## **AGENDA – Planning Commission Meeting**

**Thursday, March 12, 2020 @ 6:00 pm**

**Farley Property General Plan Amendment, Rezone, Concept Plan**

# Exhibit 2: (First Concept Plan with redlines)

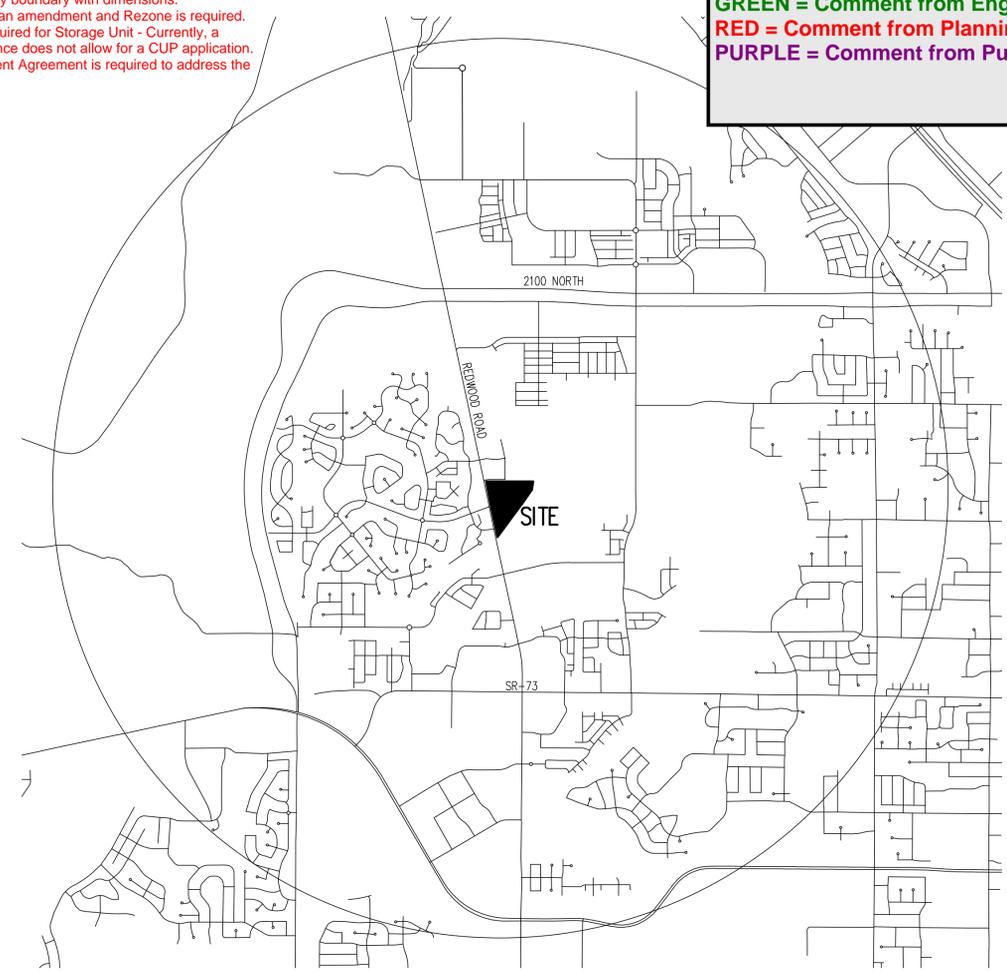
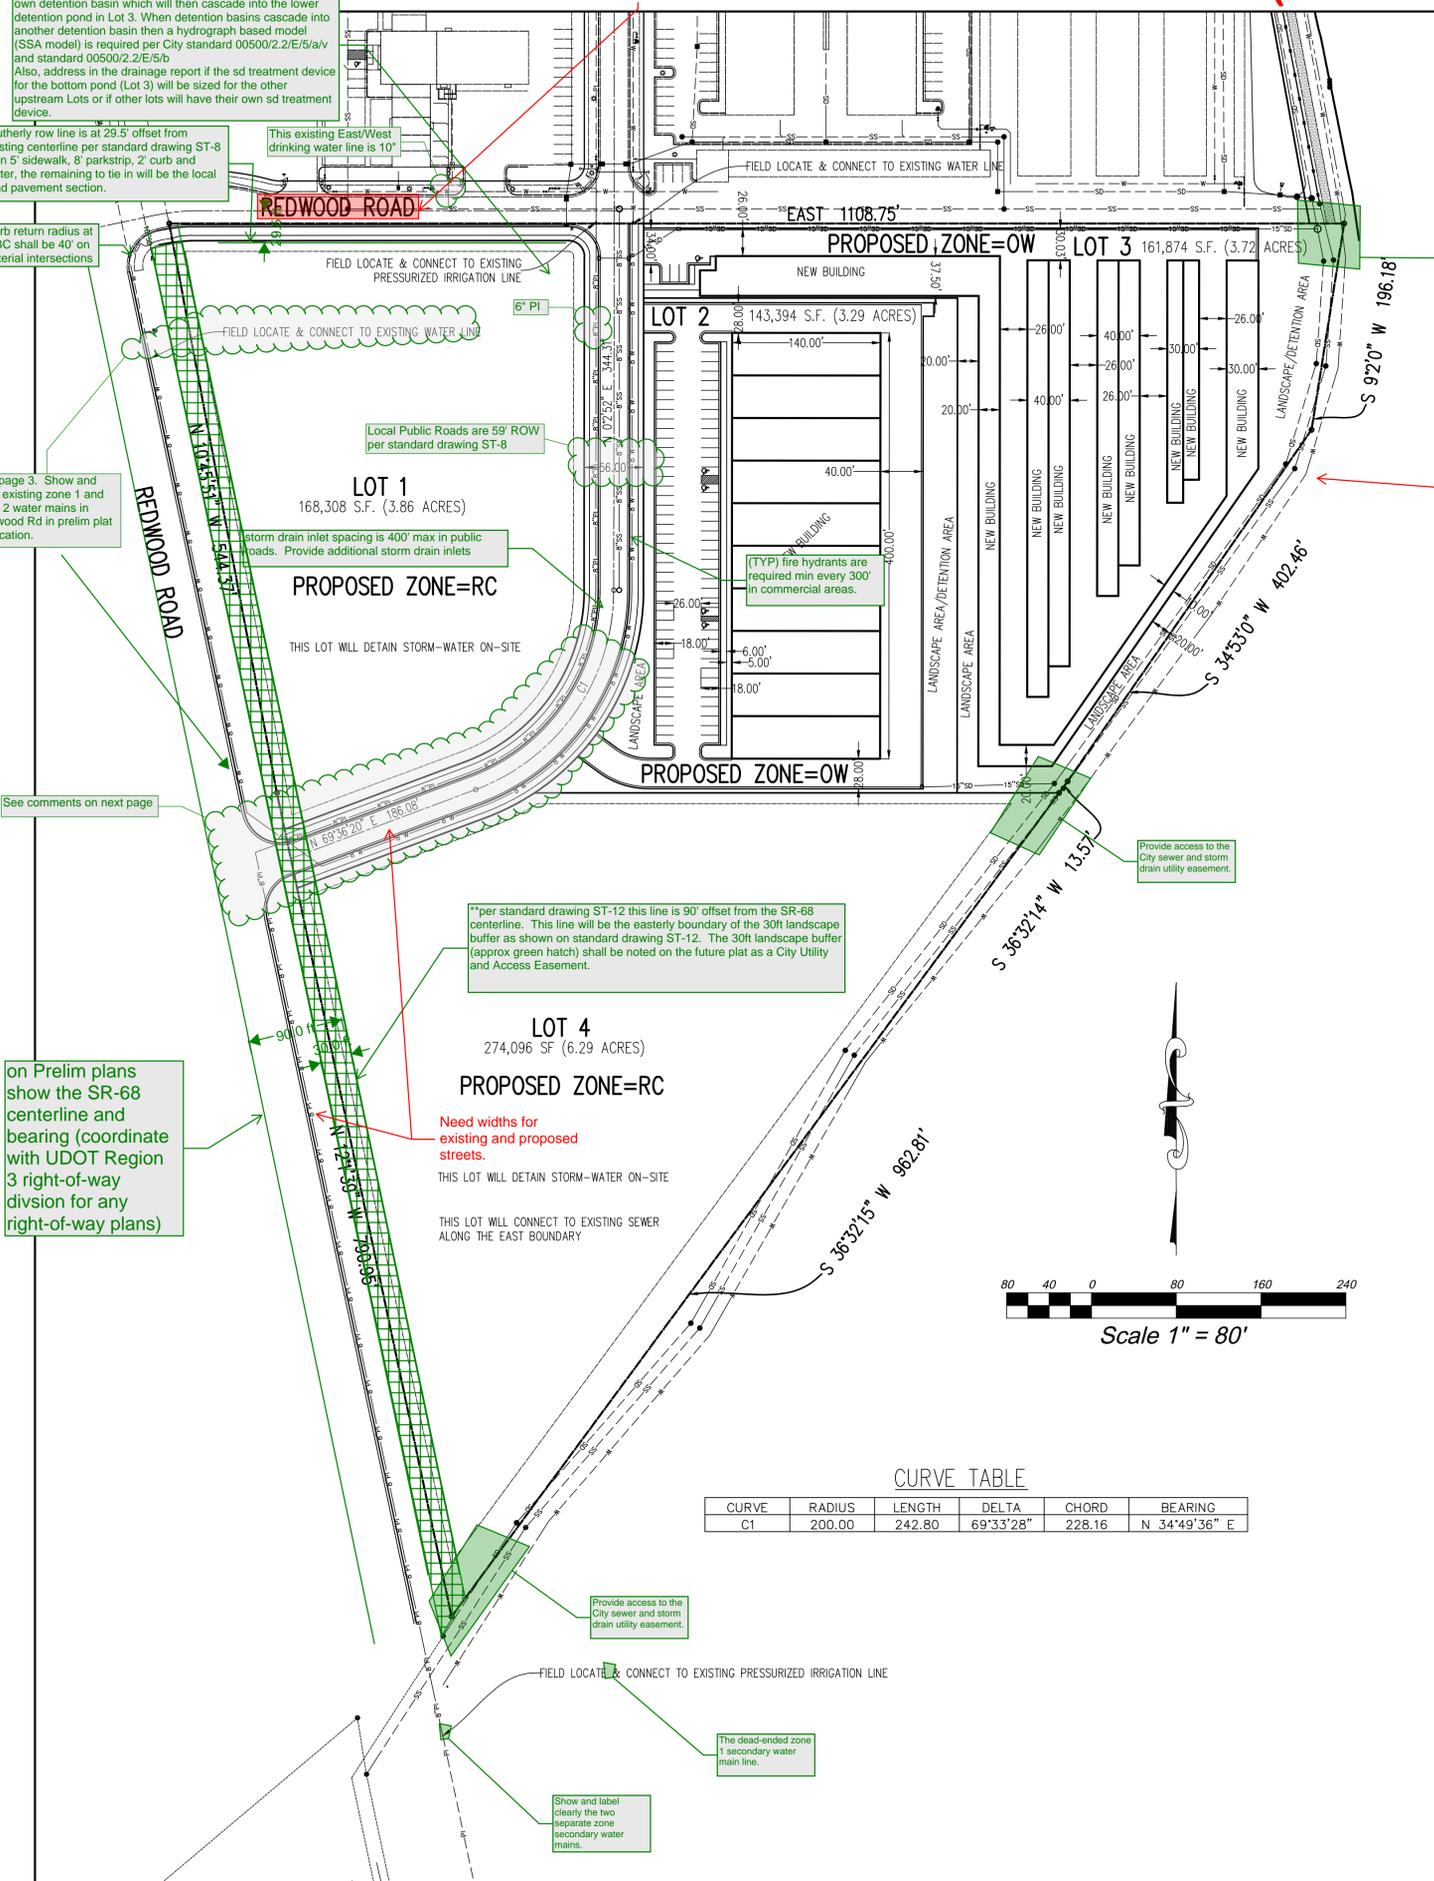
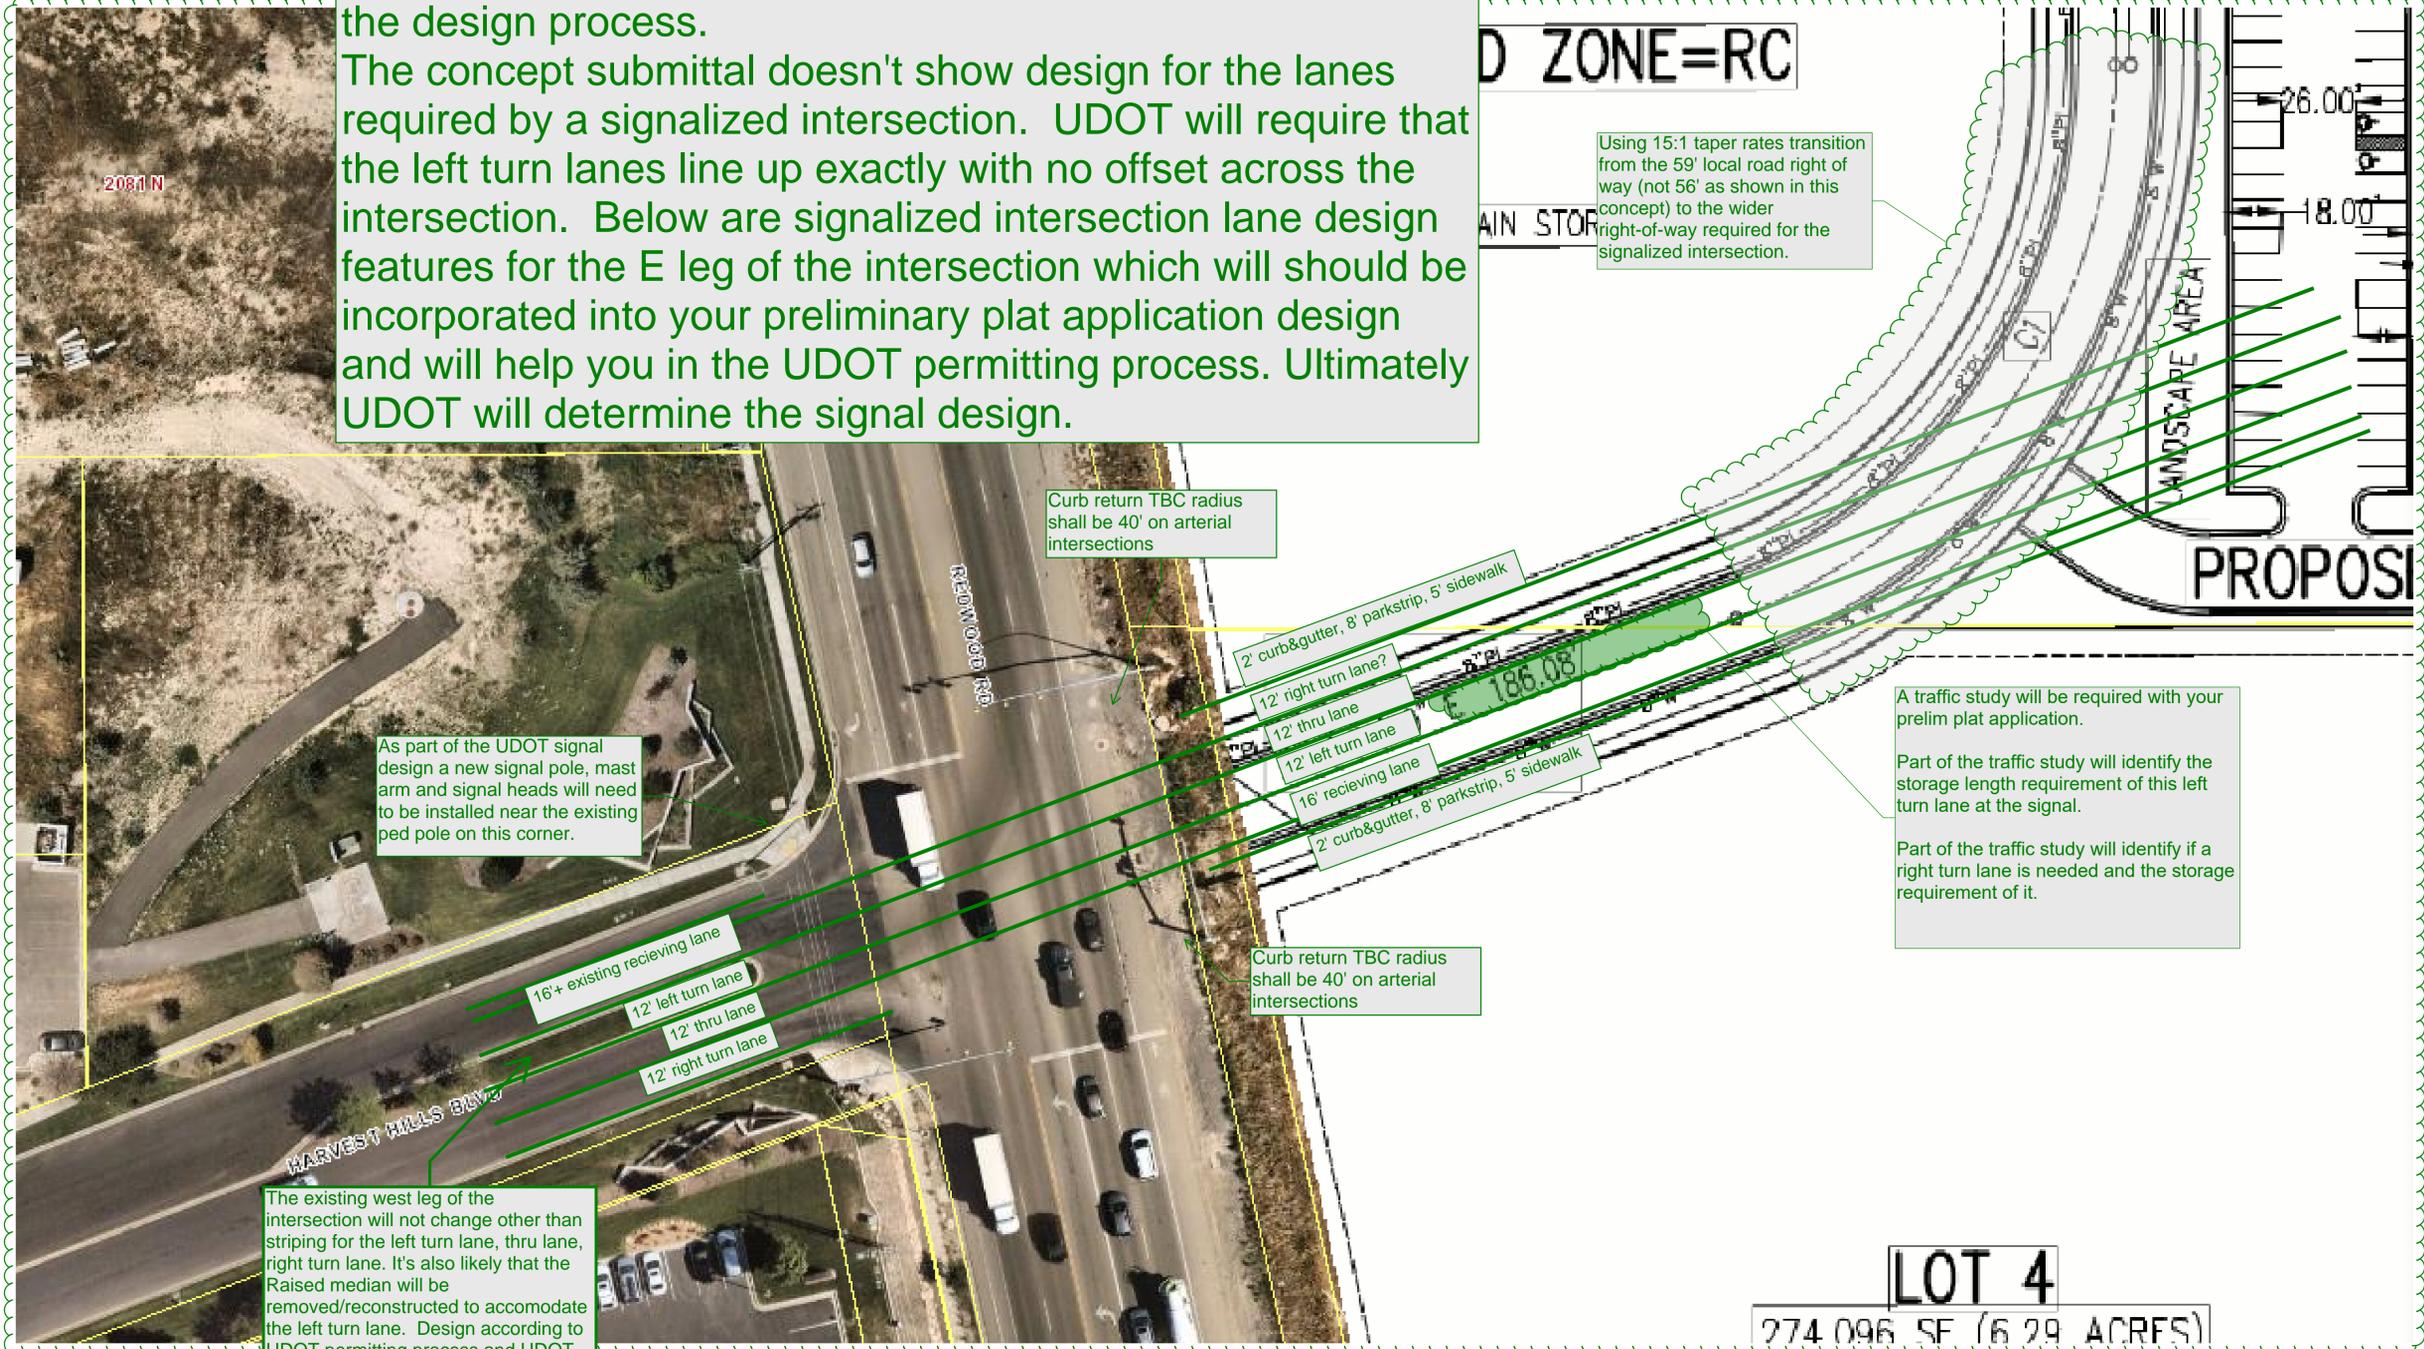
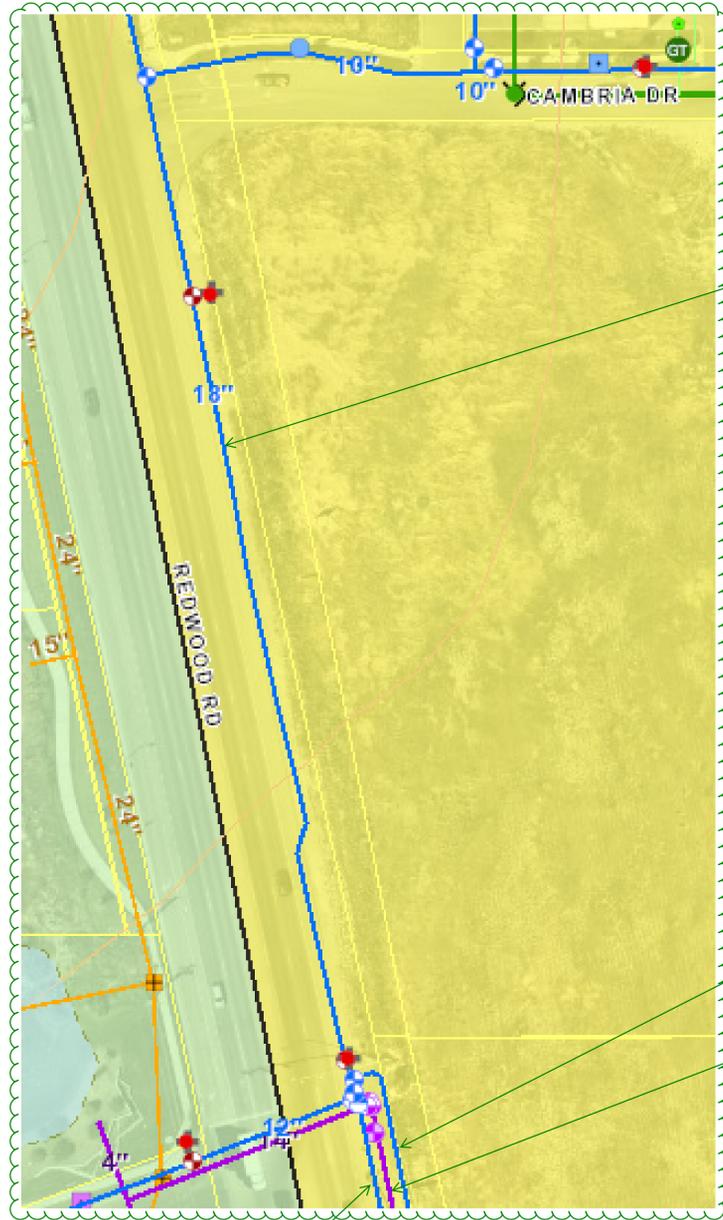
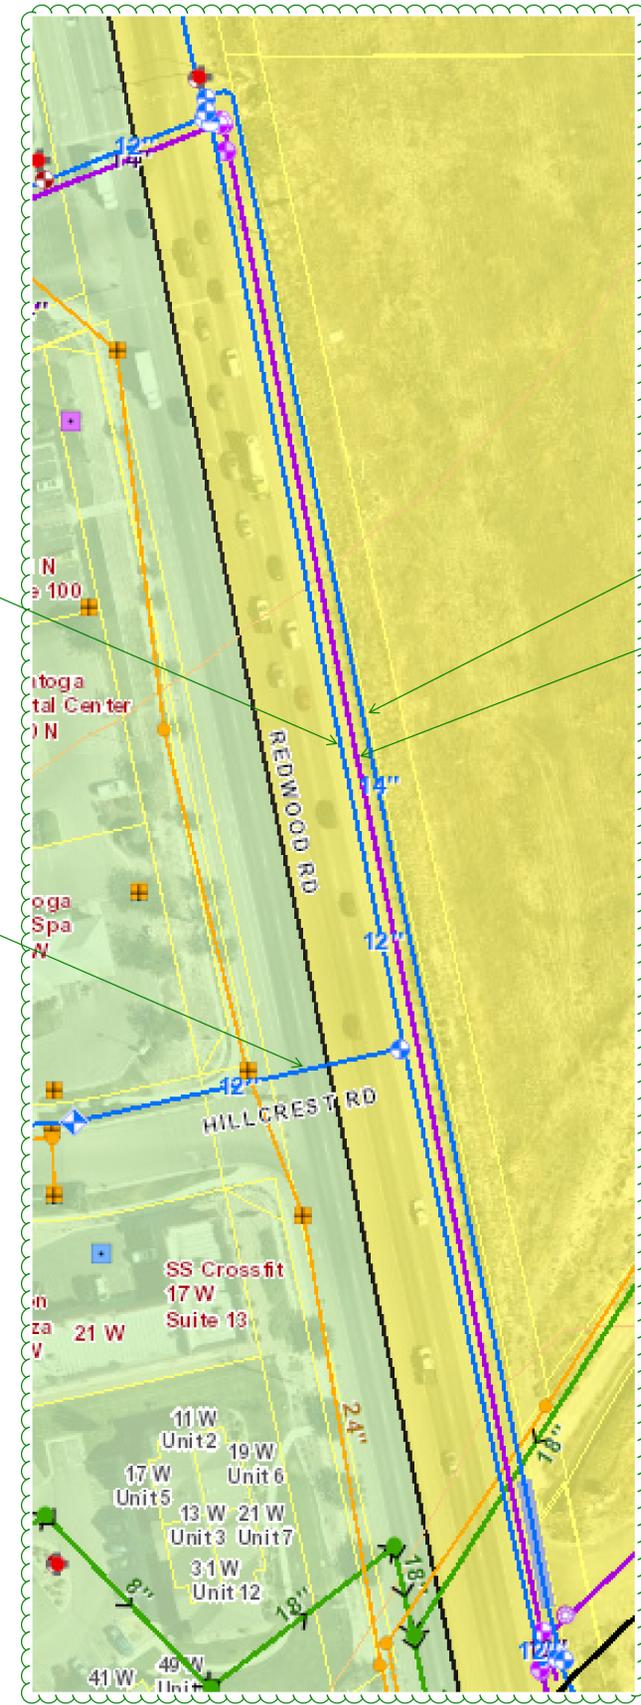
(TYP) We suggest 1 regional pond instead of a pond per lot. It appears from the concept plan that Lot 1 will have its own detention basin which will then cascade into the lower detention pond in Lot 3. When detention basins cascade into another detention basin then a hydrograph based model (SSA model) is required per City standard 00500/2.2/E/5/a/v and standard 00500/2.2/E/5/b. Also, address in the drainage report if the sd treatment device for the bottom pond (Lot 3) will be sized for the other upstream Lots or if other lots will have their own sd treatment device.

southerly row line is at 29.5' offset from existing centerline per standard drawing ST-8 then 5' sidewalk, 8' parkstrip, 2' curb and gutter, the remaining to tie in will be the local road pavement section.

curb return radius at TBC shall be 40' on arterial intersections

See page 3. Show and label existing zone 1 and zone 2 water mains in Redwood Rd in prelim plat application.

\*per standard drawing ST-12 this line is 90' offset from the SR-68 centerline. This line will be the easterly boundary of the 30ft landscape buffer as shown on standard drawing ST-12. The 30ft landscape buffer (approx green hatch) shall be noted on the future plat as a City Utility and Access Easement.

A traffic study will be required with your prelim plat application.  
Part of the traffic study will identify the storage length requirement of this left turn lane at the signal.  
Part of the traffic study will identify if a right turn lane is needed and the storage requirement of it.
